Town of Branford  
Project No. 0170-3513GR  
Pedestrian Connectivity Improvements  
Addendum #2

Date: January 24, 2025

TYPICAL PCC SIDEWALK

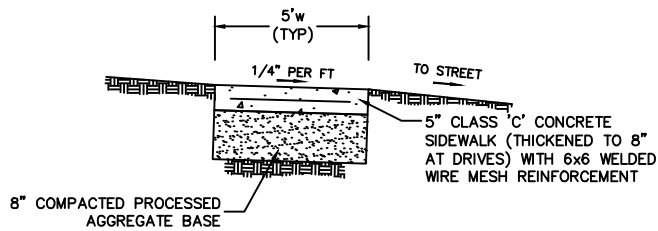
1. On the top left of page 17 the diagram looks to indicate that the Town is requiring 2 steel reinforcing pins/dowels/bars every 30', however I cannot find the spec for this. Can you provide a little clarity regarding this?

**At the final daily pour, ½” smooth metal dowels treated with bond breaker shall be inserted into the last slab of the sidewalk. Dowels shall extend a minimum of 9 inches into each slab. A pre-drilled asphalt expansion joint shall be placed over the dowels to prepare for the continuation of the sidewalk.**

**Standard details provided in the plan set are missing notes. Attached to this addendum are the standard details with all notes provided.**

- 5) AT THE FINAL DAILY POUR, 1/2" SMOOTH METAL DOWELS TREATED WITH BOND BREAKER SHALL BE INSERTED INTO THE LAST SLAB OF THE SIDEWALK. DOWELS SHALL EXTEND A MINIMUM 9 INCHES INTO EACH SLAB. A PRE-DRILLED ASPHALT EXPANSION JOINT SHALL BE PLACED OVER THE DOWELS TO PREPARE FOR THE CONTINUATION OF THE SIDEWALK.
